Project	IEEE 802.16 Broadband Wireless Access Working Group < http://ieee802.org/16 >
Title	Addition of SS Basic Capability Negotiation in Network Entry Management
Date Submitted	2007-01-18
Source(s)	Jee Hyeon Na, ETRI, E-mail: jhna@etri.re.kr Jaesun Cha, ETRI, E-mail : jscha@etri.re.kr JungMo Moon, PhD, ETRI, E-mail: jmmoon@etri.re.kr Mi-Young Yoon, ETRI, E-mail: myyun@etri.re.kr Sang Ho Lee, PhD, ETRI, E-mail: leesh@etri.re.kr Yun Won Chung, PhD, Soongsil University, E-mail: ywchung@ssu.ac.kr Ronald Mao, Huawei,
Re:	Call for Comment on P802.16g D6 Document
Abstract	This contribution proposes service primitives for network entry.
Purpose	The document should be considered during the resolution of comments on the D6 document.
Notice	This document has been prepared to assist IEEE 802.16. It is offered as a basis for discussion and is not binding on the contributing individual(s) or organization(s). The material in this document is subject to change in form and content after further study. The contributor(s) reserve(s) the right to add, amend or withdraw material contained herein.

Addition of SS Basic Capability Negotiation in Network Entry Management

Figure xxx – SS Basic Capability Negotiation Primitives (MS and BS)

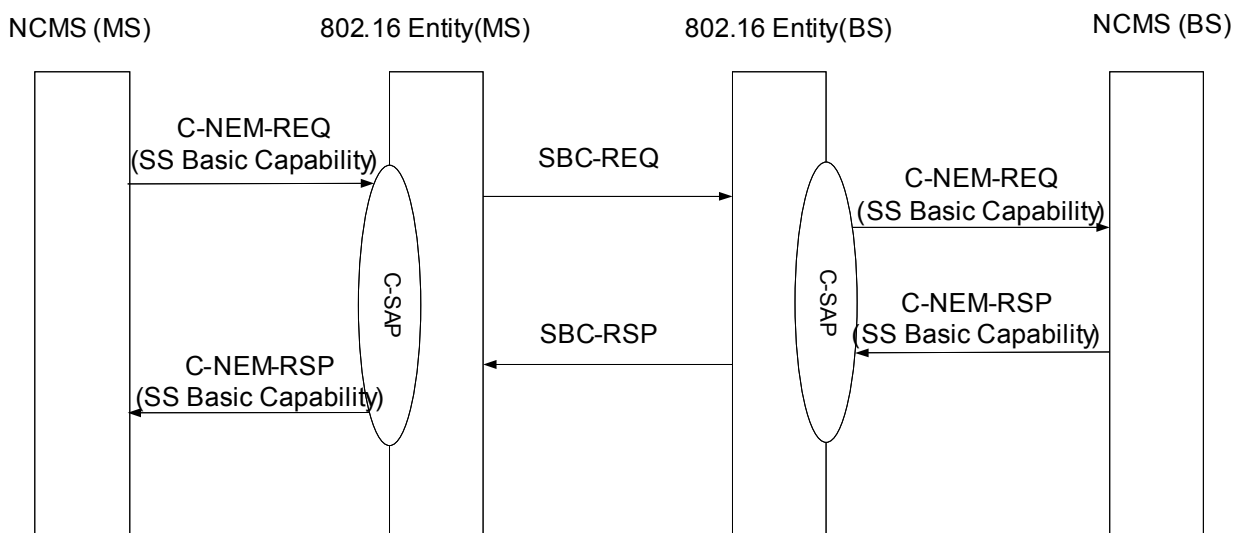
In Section 14.2.7, network entry management is described, where network entry procedure consists of ranging, registration, and network attachments. The current network entry management, however, does not contain SS basic capability negotiation during initial network entry. Since NCMS (MS) does not know when it should generate C-NEM-REQ(registration) primitive without indication from 802.16 Entity(MS) because it does not know whether SS basic capability negotiation procedure in MAC layer is completed or not, SS basic capability negotiation should be included for network entry management procedures. Thus, in this contribution, we propose to add SS basic capability negotiation primitives and related procedures in Section 14.2.7.

[Inserts the following figure between figure 498 and figure 499 in Section 14.2.7.1]
